Planning Commission
Regular Meeting

May 19, 2020
7:00 PM

2775 Henkle Drive – E-BEAM Services, Inc.

PRELIMINARY PLAN – Creekside Landing

221 N. East Street – New Single Family House

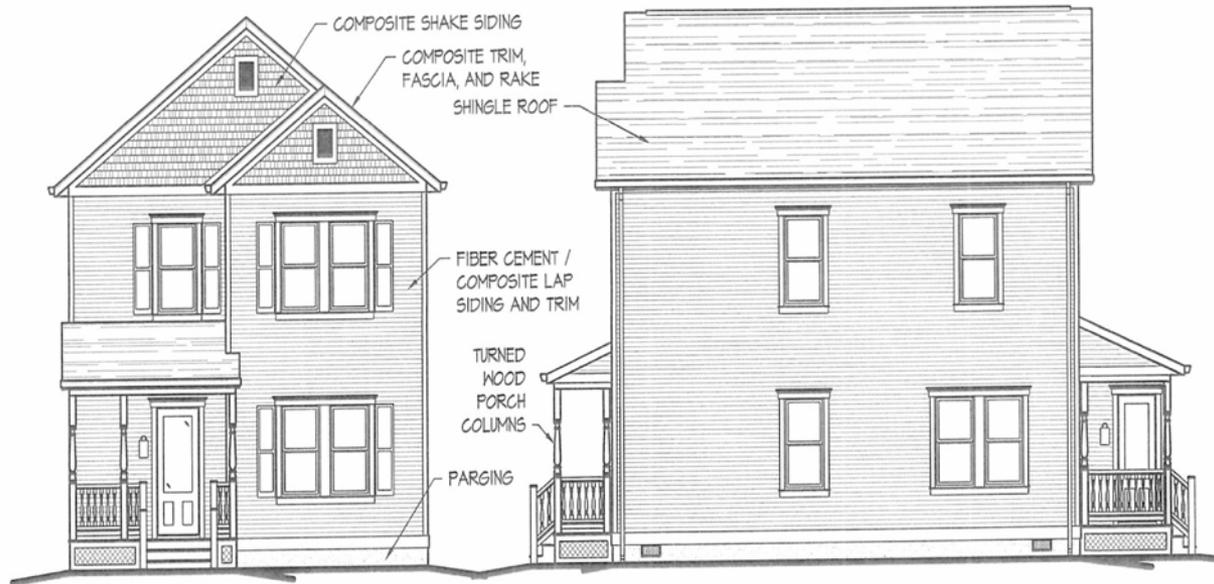
- Vacant lot
- March 19, 2019 Planning Commission approved COA for a New Single Family.
- COVID-19 outbreak slowed the applicant from moving forward.
- Requesting an extension of the COA.
- ARO District and requires the review and approval of the PC.

1. All required City permits shall be approved prior to beginning work.
2. Any variation will require Planning Commission approval.
3. Consult with the staff any future improvements, renovations, and/or refurbishment of the structure prior to beginning any related work.
4. The applicant shall have one year from March 19, 2020 to perform the work or the certificate shall expire.

35 E. Mulberry – Rear Awnings

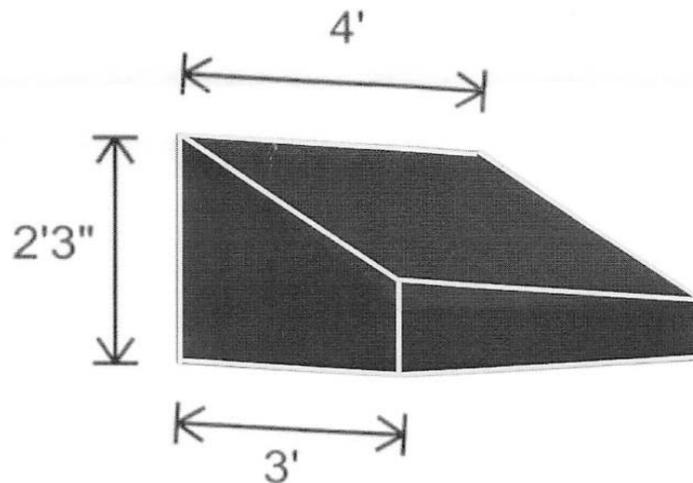
- Installation of two permanent awnings above existing doors along the rear of the commercial building.
- The installation consists of two aluminum frame awnings on the back of the building above two existing doors. The awnings are black canvas and have open sides. Each awning is 4' wide and 2'3" high, projecting 3' inches from the building face. The awning clearance above the sidewalk is eight (8) feet.

1. The addition of the awnings complements the overall building design.
2. The proposed awnings are in scale with the existing building.
3. The awning design and material comply with the standards required in Ch. 1140.

1. All required city permits shall be approved prior to installation.

2775 Henkle Drive – E-BEAM Services, Inc.

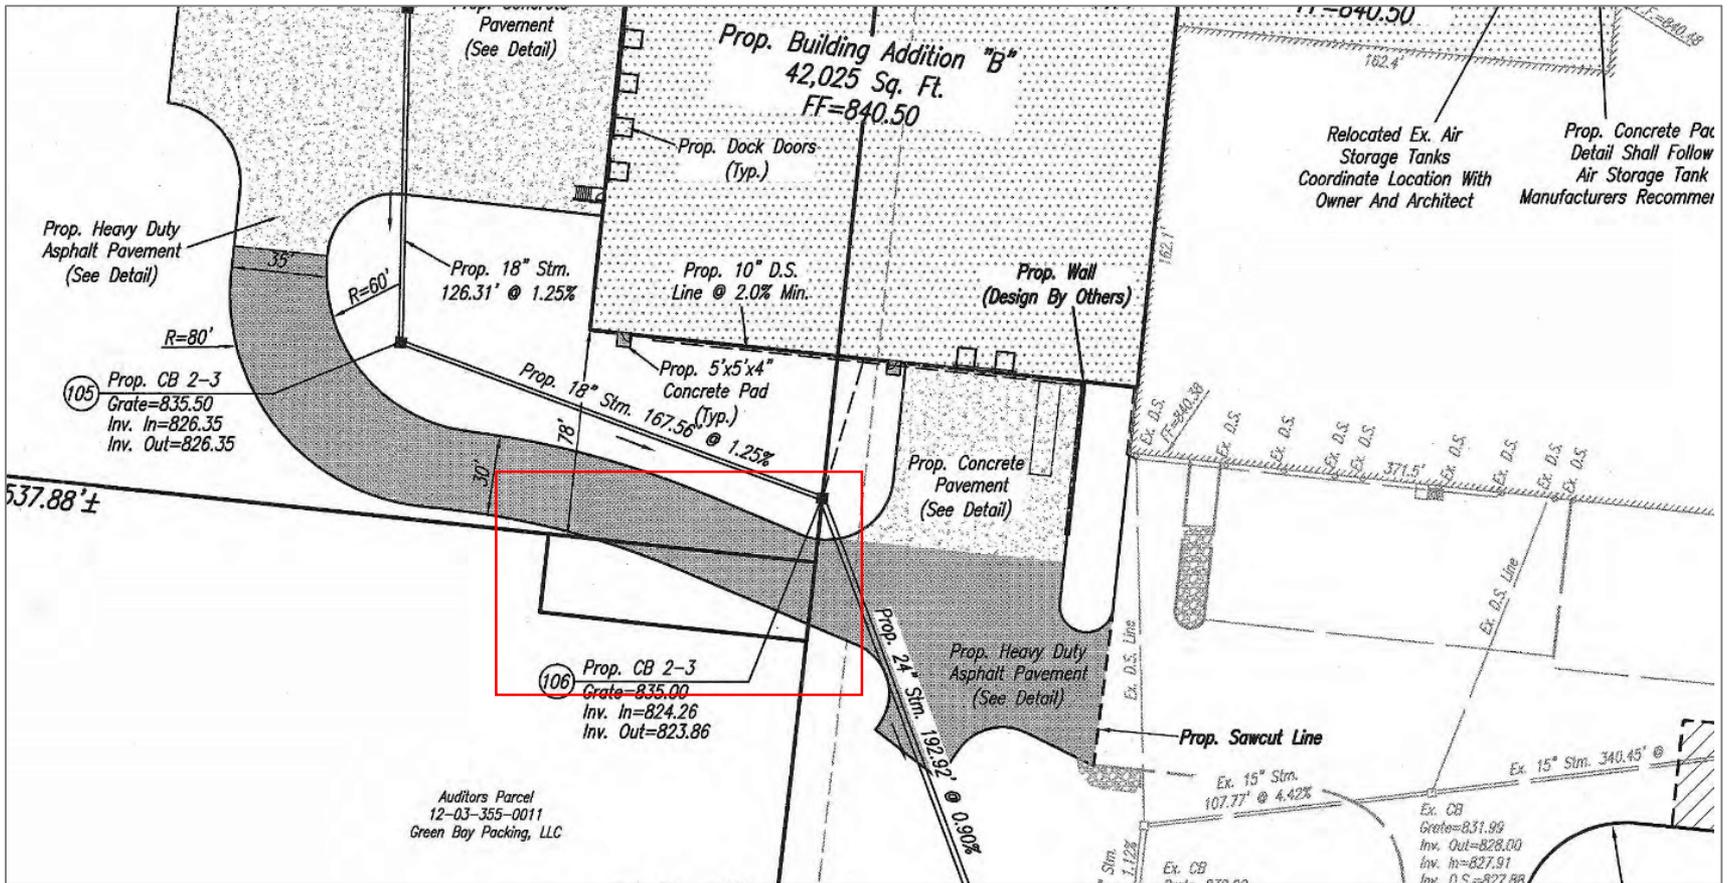
- The expansion plans for the facility were reviewed as a minor site plan in accordance with Section 1132.06 E.1.
- The code provides for administrative review of minor site plans for developments within the I-P, I-1 or I-2 zone that are subject to local tax incentives.
- An interdepartmental review has occurred and the plans are currently being revised by the applicant.
- The proposed project substantially complies with the zoning code standards.

- An interdepartmental review has been conducted and the proposed project substantially complies with the zoning code standards.
- The portion of the access drive on the south side of the building that is located on Green Bay Packaging's property is an 85' x 23' triangle section of approximately 980 s.f. of pavement.
- Green Bay Packaging has agreed to the encroachment and a dedicated cross-access easement of 30' x 100'.
- Where the language in the zoning code doesn't specifically address this situation, the provisions stated in the staff report acknowledge very similar situations are permitted with Planning Commission review and approval.

1. All interdepartmental review comments and markups shall address before issuance of a Zoning Permit.
2. All applicable permits shall be issued prior to the start of construction.
3. Any variation from the approved plans will require additional approval.

Development Layout

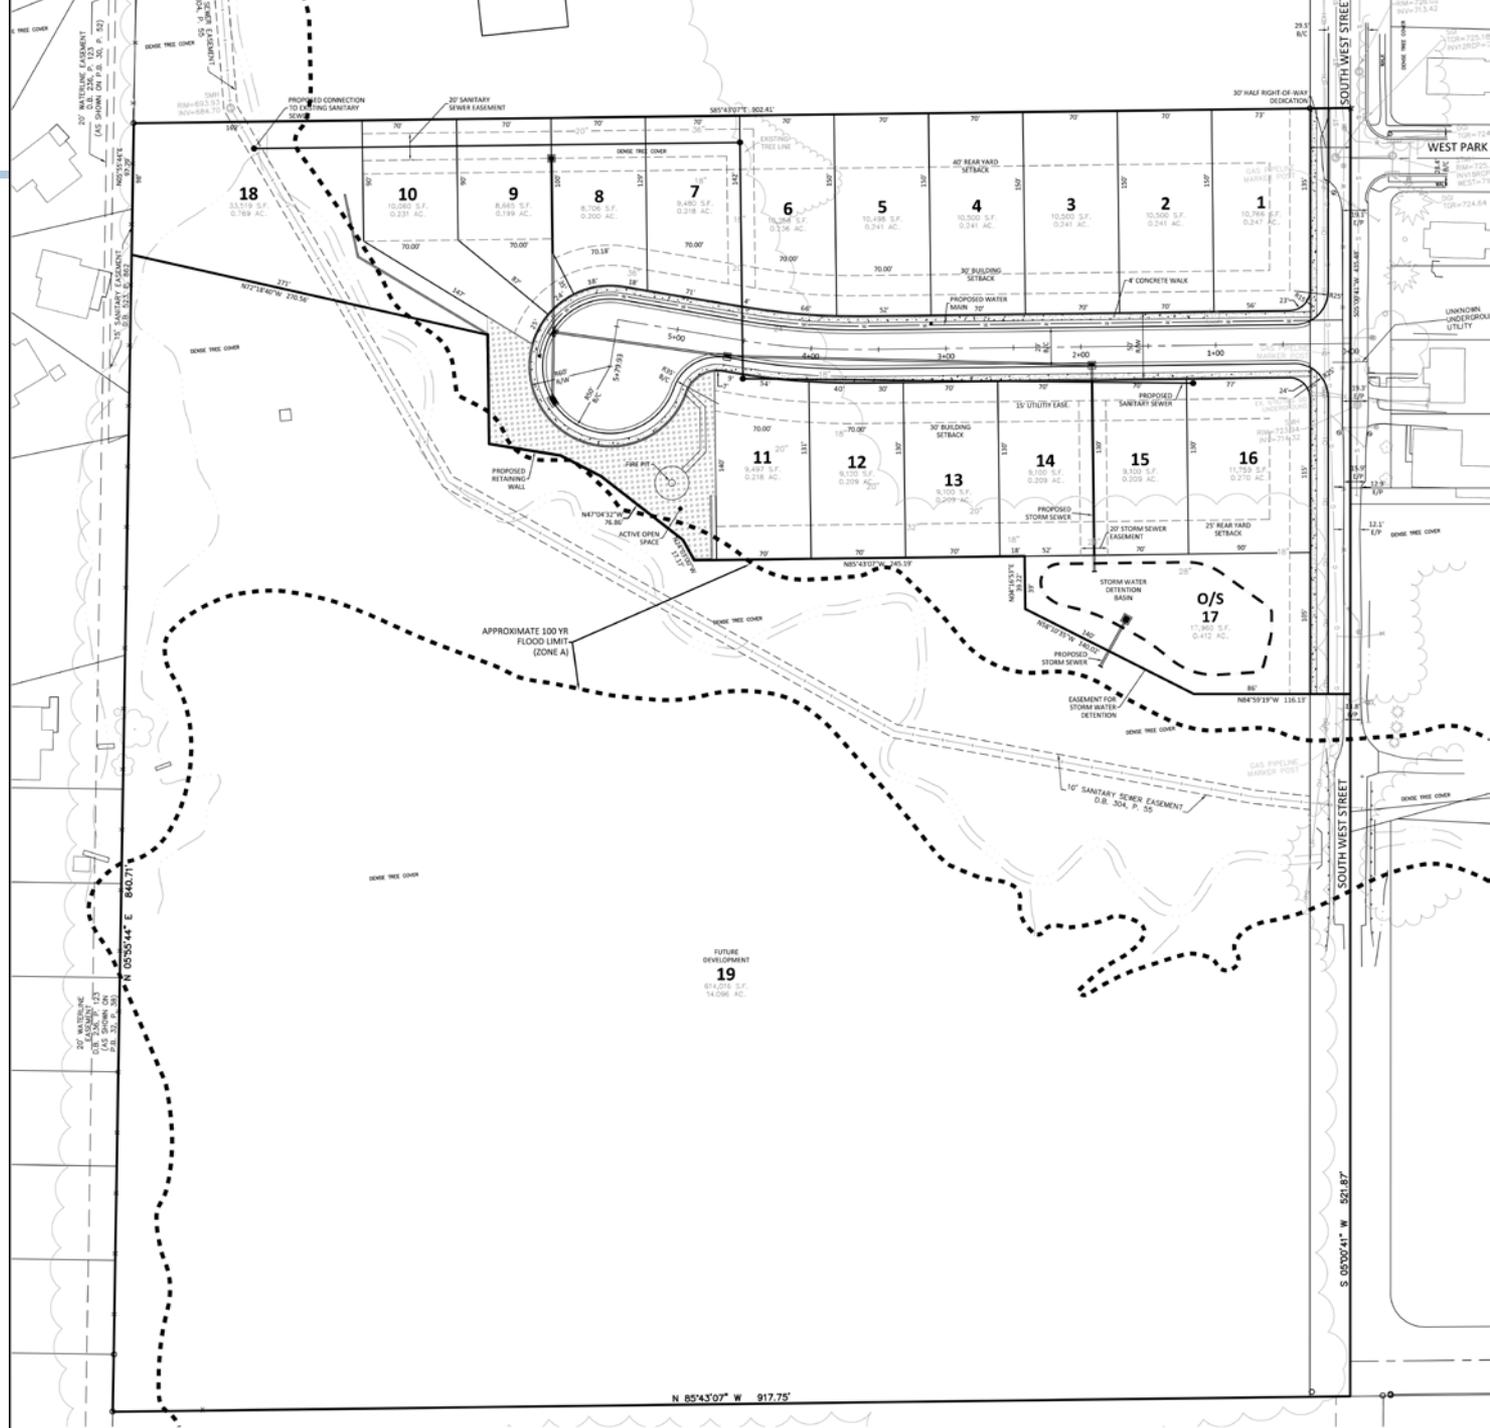
Phase I is located
on the northern
portion of the
property.

Access Management The proposed two lane street will intersect with S. West Street near W. Park Avenue and end in a cul-de-sac. Due to the location of the property, the street will not be lined up directly from W. Park Avenue. The street will be straight, keeping with the urban pattern of the adjacent roadways.

1. All plan corrections as required by interdepartmental review.
2. The final plat for Creekside Landing shall be submitted to the Planning Commission for review by 5/19/21. Failure to submit the final plat for approval or request an extension by the Planning Commission will cause the preliminary plan to expire and become null and void.

Development Standards

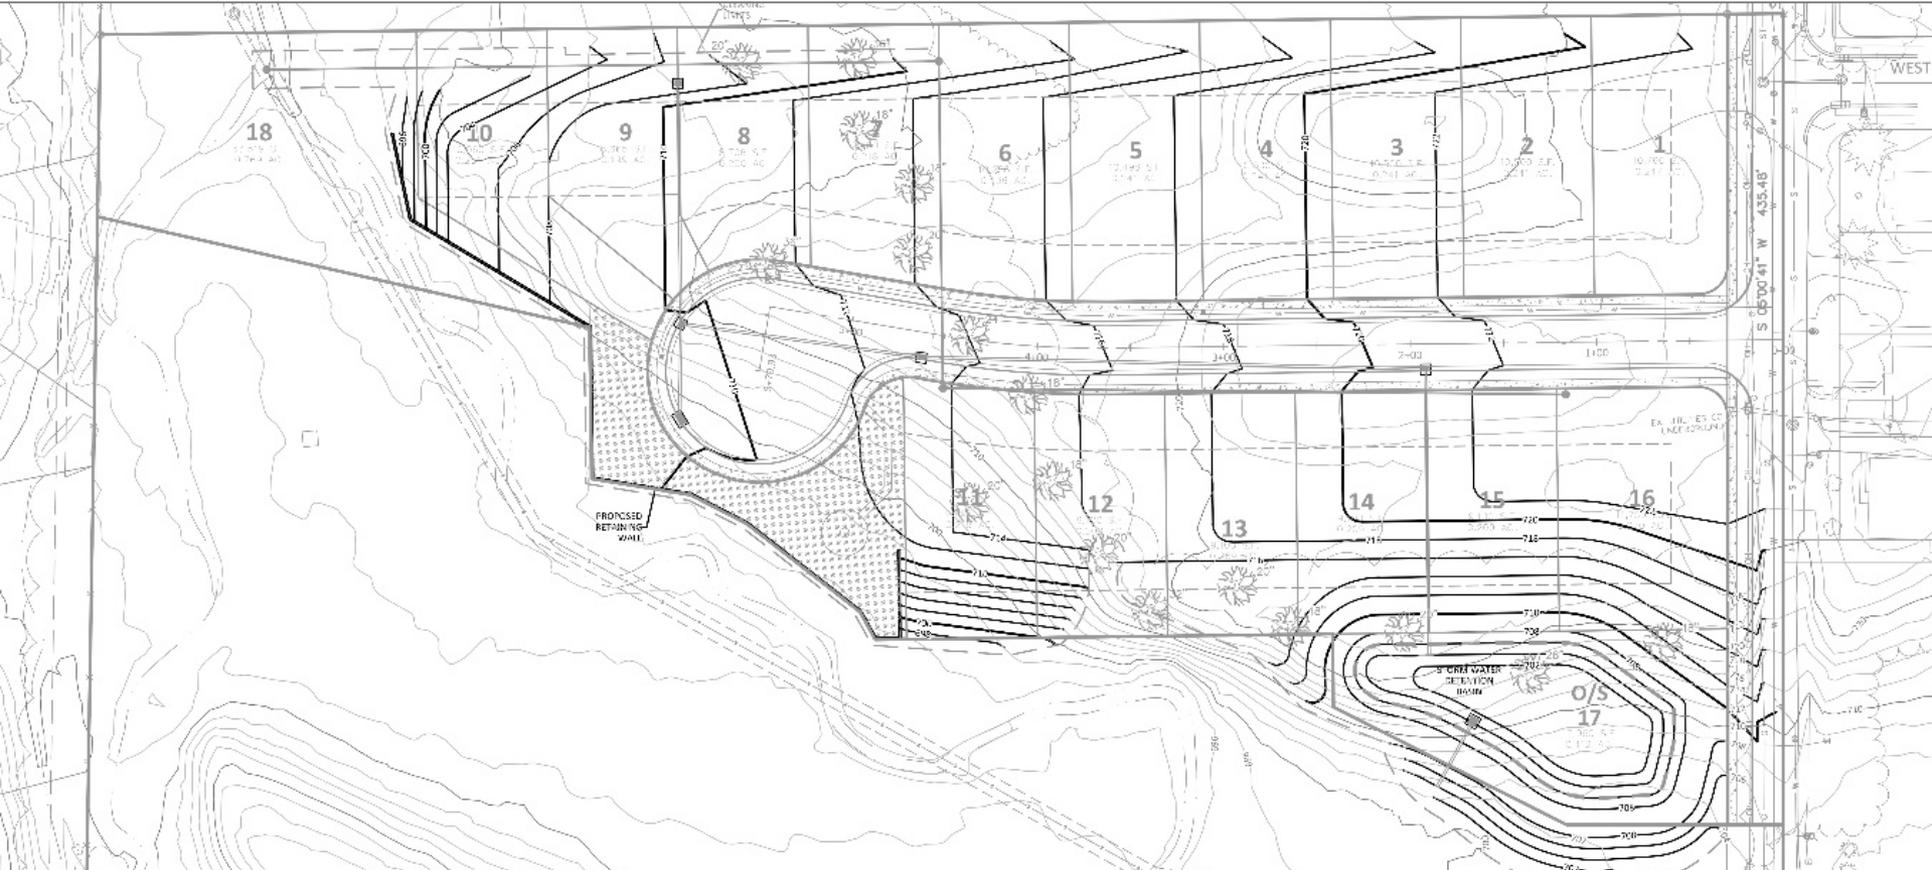
- Lots 17 and 18 are a total of 1.181 sloped and wooded acres that are designated as open space in response to the development standards requiring 20% open space in any new residential development.
- Active open space must account for 20% of the allocated open space area and the plan depicts 0.236 acres with a gathering area and fire pit to comply with that standard.

Street Trees – The plans provide the 24 required large street trees to meet this standard.

Buffer Requirements - The site is adjacent to an I-1 Light Industrial Zone. The plan depicts the alternate buffer plan of a 6' high solid wood fence with 6 deciduous trees and three shrubs per 100 linear feet. There is a total of 625 linear feet and the applicant has provided 30 trees and 21 shrubs to meet the requirements.

Replacement Trees – There are 17 significant trees on the site. The applicant will save 4 large trees and 13 will need to be removed to construct this development. 3 fall within the stormwater management system. Replacement of 10 trees for a total of 153 caliper inches requiring 77 - 2" caliper trees. The applicant is depicting 77 additional trees in the subdivision to fulfill the replacement quota.

Stormwater Management: Handled through curb and gutter along the street captured by catch basin leading to the detention basin in the south east corner of Phase I. The northern border has a swale along the back side of the property to collect on-site drainage along the back side of the properties.
